### Notice of Intent

**Type of Action:** APD Change

**Procedure Description:** Matador requests the option to amend the well design of the Juniper 25 36 34 Fed Com #103H, #114H, #094H, #082H, and #123H by changing the set depth of the intermediate 1 casing strings as per the drill plans attached. Cement volumes will be adjusted accordingly. Justification for these set depths are included in the form of the Bell Canyon top displayed on directly adjacent logs.

## PECOS DISTRICT DRILLING CONDITIONS OF APPROVAL

## 4-String Wellhead Diagram

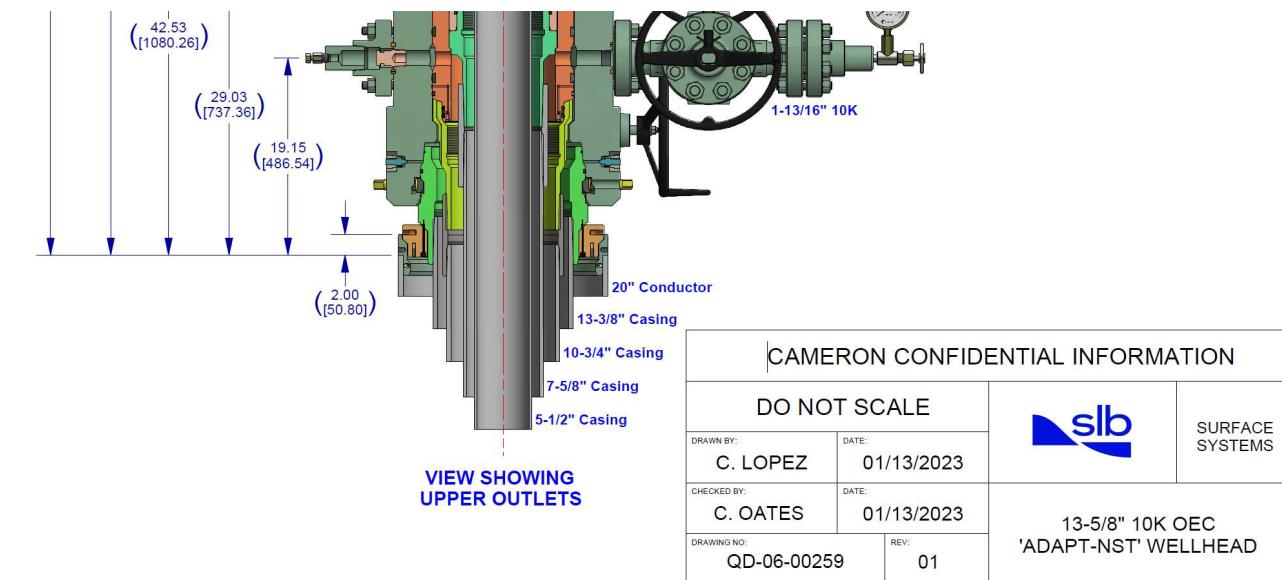
Matador request option to switch to Design B (4 string) if losses are observed in Capitan Reef. If losses are observed, an additional intermediate casing string will be ran to isolate losses. No other changes in well design are required. The 10-3/4" SC casing spec sheet along with 4-string wellhead diagram are attached.
